RM230016 MANGAKURI SUBDIVISION – 402 MANGAKURI ROAD, MANGAKURI

A Section 92 letter (S92) dated 18 September 2023 was subsequently received from Central Hawkes Bay District Council (CHBDC). This letter report has been prepared to address the Transportation questions raised by this letter.

Figure 2 – Williams Road Northern Access North Approach

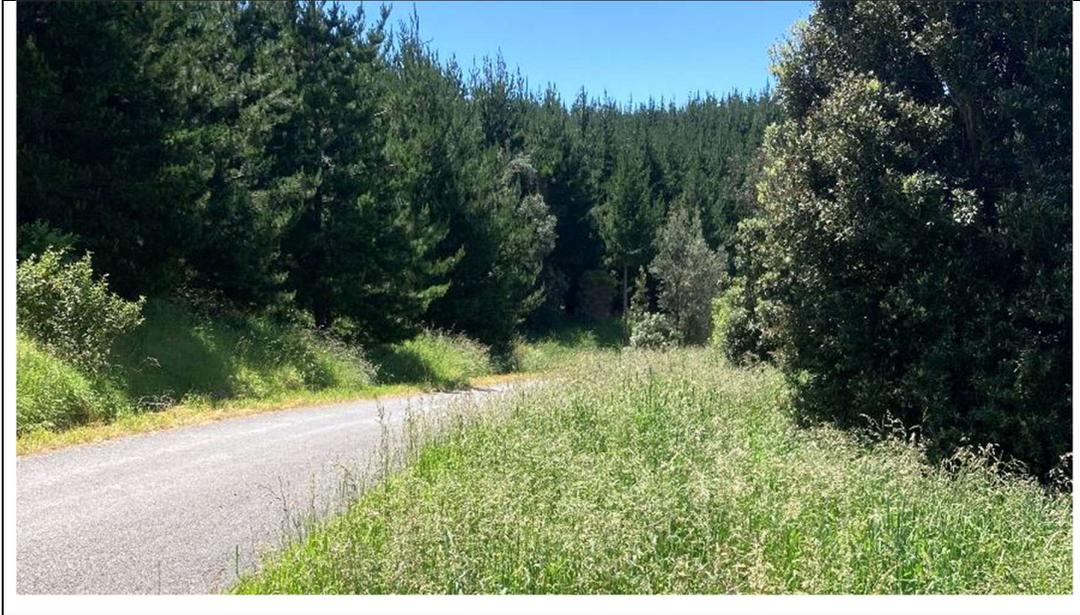
Austroads states that desirably sight distances at access should comply with the sight distance requirements for intersections³. Accordingly, the sight distance requirements given in Section 4.1 of the TAR increase to 97m for a 50km/h speed environment.

As a result of the increased sight distance recommendations four trees within the road reserve should be selectively limbed (to allow sight lines below the canopy) and/or removed to the north of the northern access as shown in Figure 4.

Once these trees are trimmed/removed, 97m of sight distance can be achieved in both directions from all accesses as shown in Figures 11 to 16 of the TAR. Regular berm mowing is still recommended to ensure the sight lines are kept clear of vegetation, this will keep grass height low and prevent new trees/bushes from establishing.

Figure 3 – Okura Road Access Exit Gradient

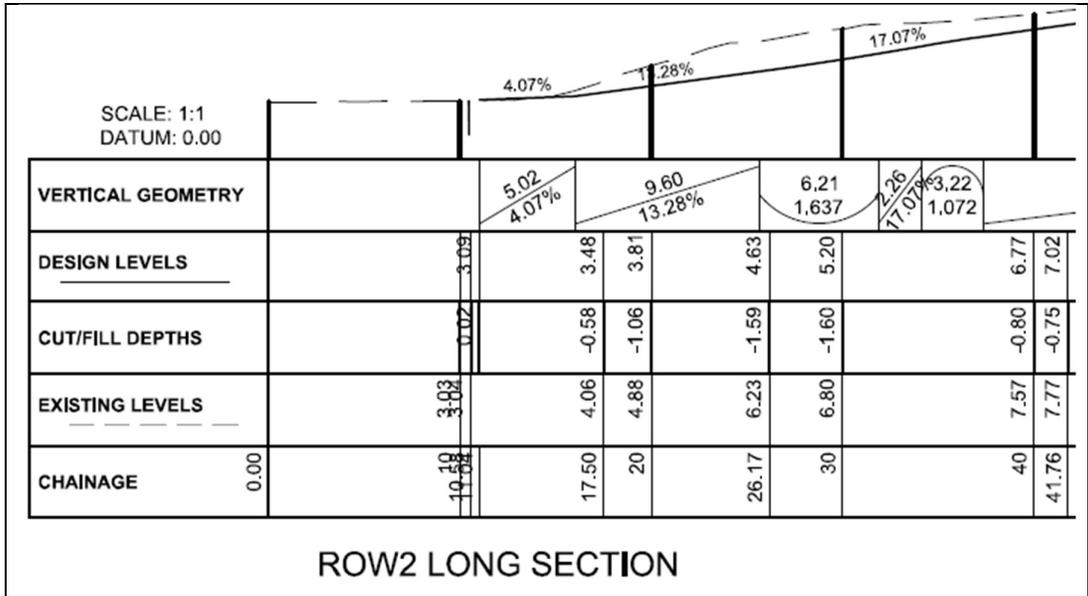
5. Please confirm whether a 5 metre long approach platform with a gradient of less than 5 percent will be provided on each right of way where they meet the frontage road. If not, please confirm what approach/gradients will be provided with appropriate diagrams to demonstrate this, as necessary.

All three accessways include an approach platform as recommended in the TAR. The Figures below have been extracted from the Strata Group Limited plans to show each specific accessway approach platform gradient.

Figure 6 – Okura Road Access Vehicle Tracking

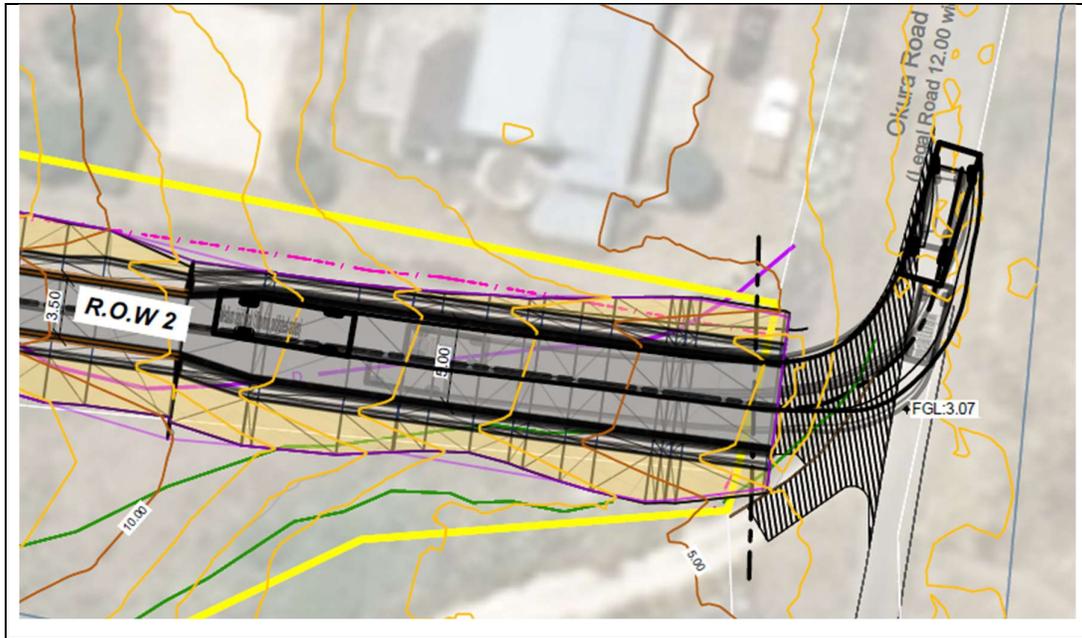
7. Please advise whether a medium length truck can turn without leaving the carriageway for ROW 2. If this is proposed, please update the ROW2 / Okura Road crossing design.

Figure 8 has been extracted from the Strata Group Limited plans to demonstrate the accessway provisions are suitably dimensioned as recommended by the TAR. The access is 5m wide over approximately 50m to ensure sufficient space for vehicles to manoeuvre past each other. No widening is recommended along the beach side of Okura Road. Medium rigid trucks (MRTs⁴) are only expected to access the site during construction or if a large fire appliance is called, in this case the vehicle body may overhang the edge of seal but wheels are expected to remain on the sealed surface.
